DSO9404A-03 <u>S E R V I C E N O T E</u>

DSO9404A - 4GHz Digital Signal Oscilloscope

Repair for Windows "Power surge on hub" message

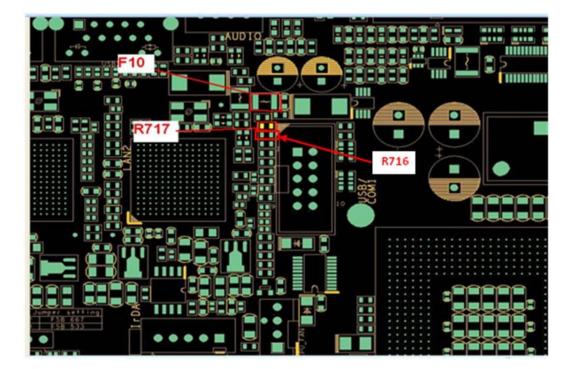
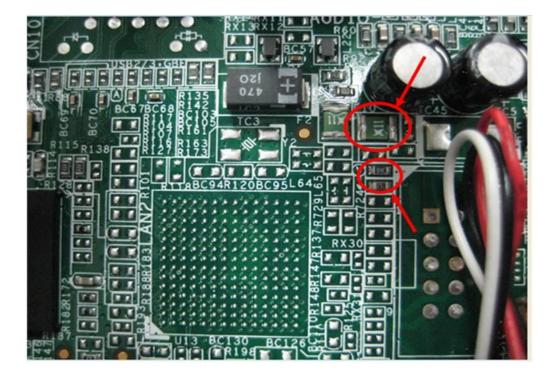
- 1. Refer to the service manual to remove the motherboard from the scope.
- 2. Install the three components from the upgrade kit on the motherboard. Refer to the below drawing and the drawing on the next page for component locations. The 0960-2789 motherboard is RoHS compliant and the below three components are also RoHS compliant. You should use a RoHS soldering station and RoHS solder techniques when possible.

F10 – 0837-3854 Thermistor

R717 – 0699-7654 10K Resistor

R716 – 0699-5789 15K resistor
